9311 BRENDA ANN RD

Mecklenburg County
Health Department

RE: Property located at 9311 Brenda Ann Road 10
FILE: 7871A
PARCEL: 113-163-02

MECKLENBURG COUNTY ENVIRONMENTAL HEALTH
SITE EVALUATION REPORT
SERIAL NUMBER 12382

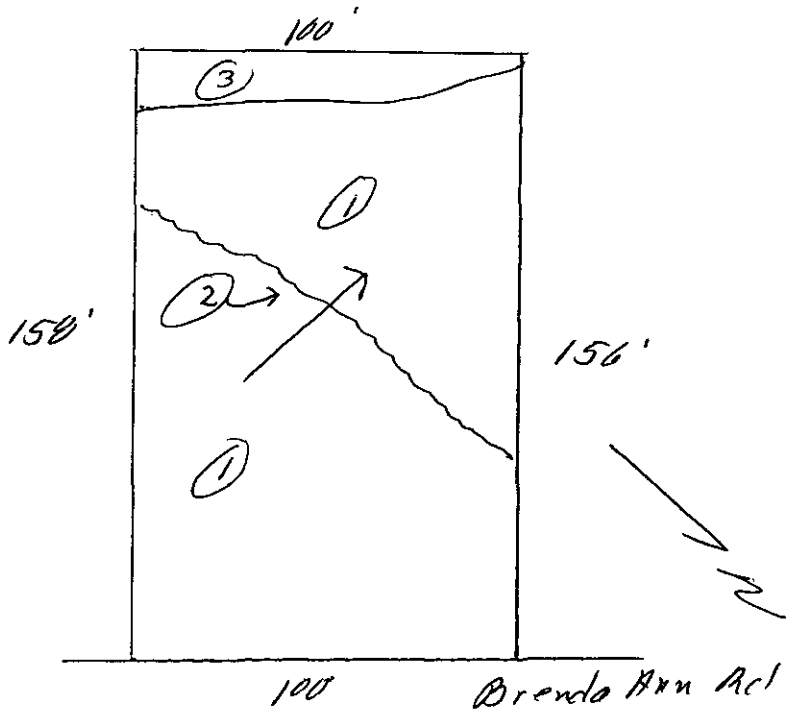
FACTORS	AREA 1	AREA 2	AREA 3	AREA 4	AREA 5	AREA 6
Topography	S (PS) U 6-20%	S PS (U) complex stone CTerrain	S PS (U) Depression	S PS U	S PS U	S PS U
Texture	S (PS) U Slightly Expansive clay	S PS U —	S PS U —	S PS U	S PS U	S PS U
Structure	S (PS) U sub Blocky	S PS U —	S PS U —	S PS U	S PS U	S PS U
Drainage	(S) PS U 7+8" To water	S PS U —	S PS U —	S PS U	S PS U	S PS U
Depth	(S) PS U 7+8"	S PS U —	S PS U —	S PS U	S PS U	S PS U
Restrictive Horizons	(S) PS U 7+8"	S PS U —	S PS U —	S PS U	S PS U	S PS U
Available Space	S PS (U) Restricted	S PS U —	S PS U —	S PS U	S PS U	S PS U
Other (specify)	S PS U	S PS U	S PS U	S PS U	S PS U	S PS U
Soil Group/Series	IV Cecil-Lilo	Terrace	Depression			
Area Classification	S PS (U)	S PS (U)	S PS (U)	S PS U	S PS U	S PS U
